本書には、以下に示す誤りがございました。お詫びして訂正いたします。

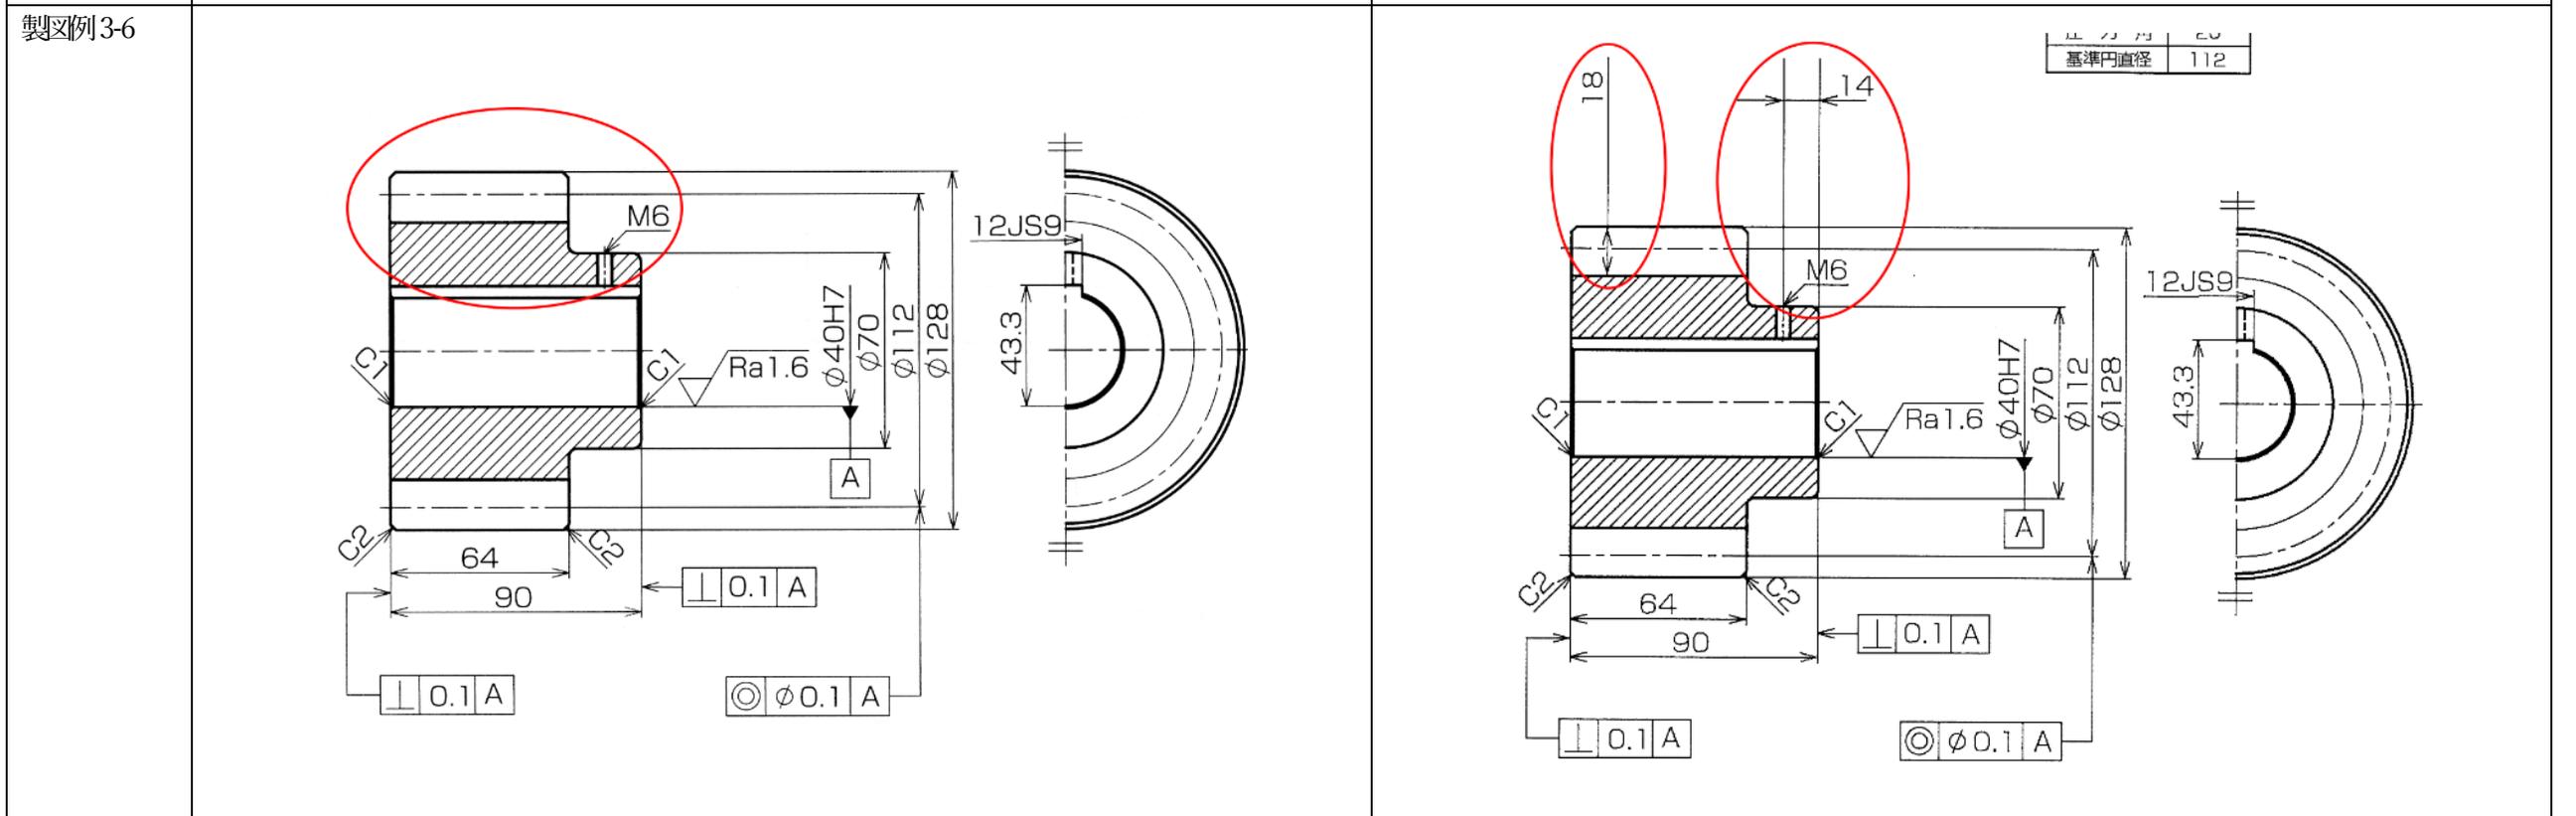
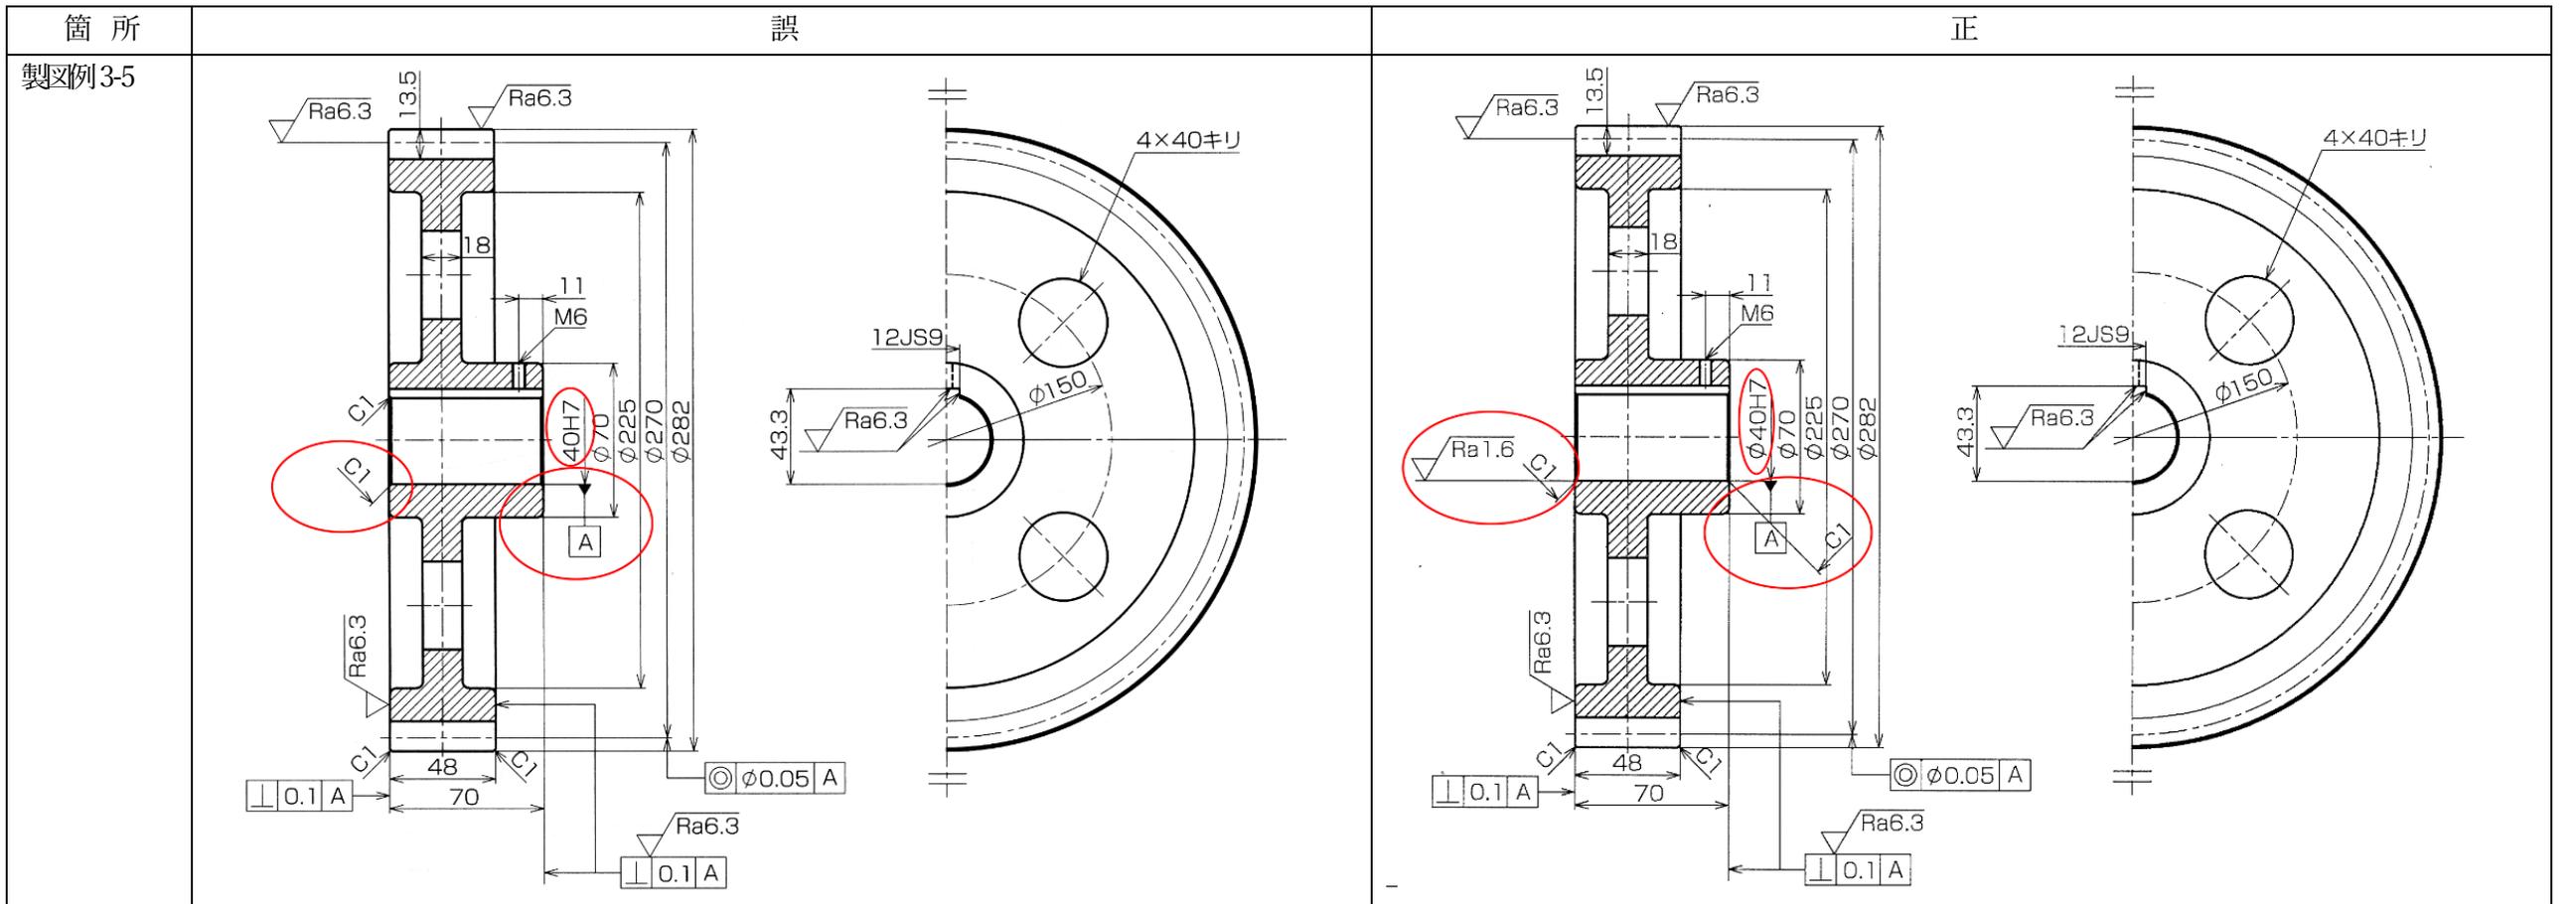
箇所	誤	正
製図例3-15	<p>Technical drawing of a shaft with errors. The shaft has a total length of 760, with a central section of length 700. It features chamfered ends (C1) with a length of 30, a diameter of 30e8, and a surface finish of Ra1.6. A feature with a diameter of 70 and length 178 is also shown. A feature control frame is incorrectly drawn with a vertical line and a horizontal line, containing the values 0.1 and 0.05/200.</p>	<p>Technical drawing of the same shaft as in the '誤' column, but with the feature control frame corrected. The feature control frame now has a horizontal line and a vertical line, containing the values $\phi 0.1$ and $\phi 0.05/200$.</p>
製図例3-16 右 ㉔	<p>Technical drawing of a shaft with errors. The shaft has a diameter of 20 and a length of 356, with a central section of length 300. It features chamfered ends (M16) with a length of 26. Two feature control frames are incorrectly drawn with vertical lines, containing the values 0.1 and 0.1.</p>	<p>Technical drawing of the same shaft as in the '誤' column, but with the feature control frames corrected. The feature control frames now have horizontal lines, containing the values $\phi 0.1$ and $\phi 0.1$.</p>

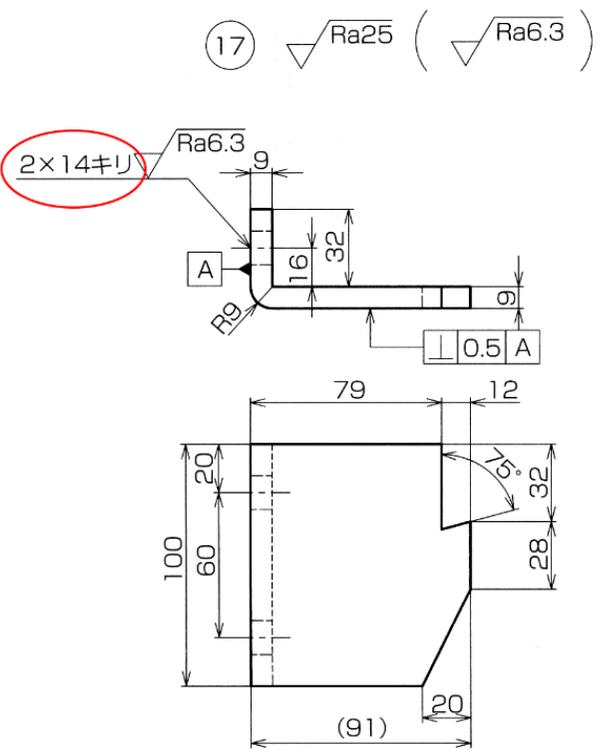
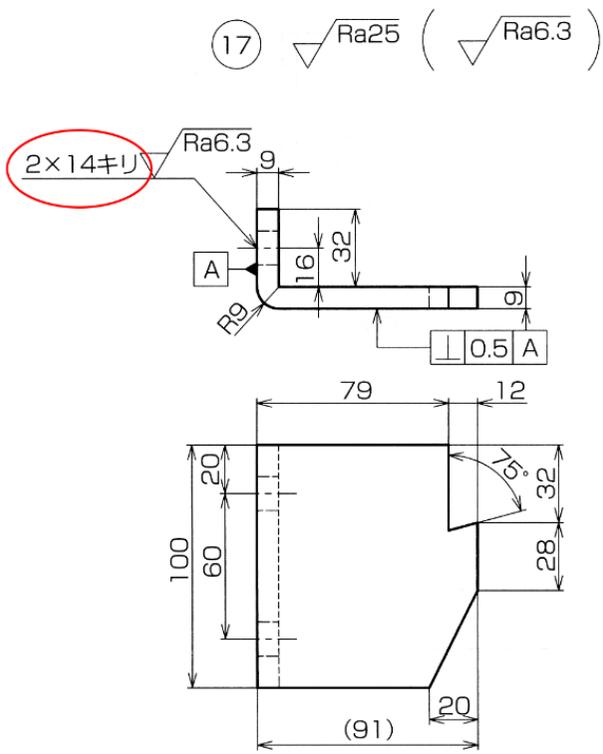
箇所	誤	正
製図例3-7	<p>Technical drawing of a shaft-hub assembly (Example 3-7) showing manufacturing errors. Red circles highlight incorrect feature control frames: one for surface texture (Ra6.3) and one for circular runout (A). A red oval highlights an incorrect diameter dimension of 496 instead of 446.</p>	<p>Corrected technical drawing of the shaft-hub assembly. Red circles highlight the corrected feature control frames for surface texture and circular runout. A red rectangle highlights the corrected diameter dimension of 446.</p>
製図例3-8	<p>Technical drawing of a shaft-hub assembly (Example 3-8) showing manufacturing errors. Red circles highlight incorrect feature control frames: one for surface texture (Ra6.3) and one for circular runout (A). A red oval highlights an incorrect circular runout feature control frame for a hole.</p>	<p>Corrected technical drawing of the shaft-hub assembly. Red circles highlight the corrected feature control frames for surface texture and circular runout. A red oval highlights the corrected circular runout feature control frame for the hole.</p>
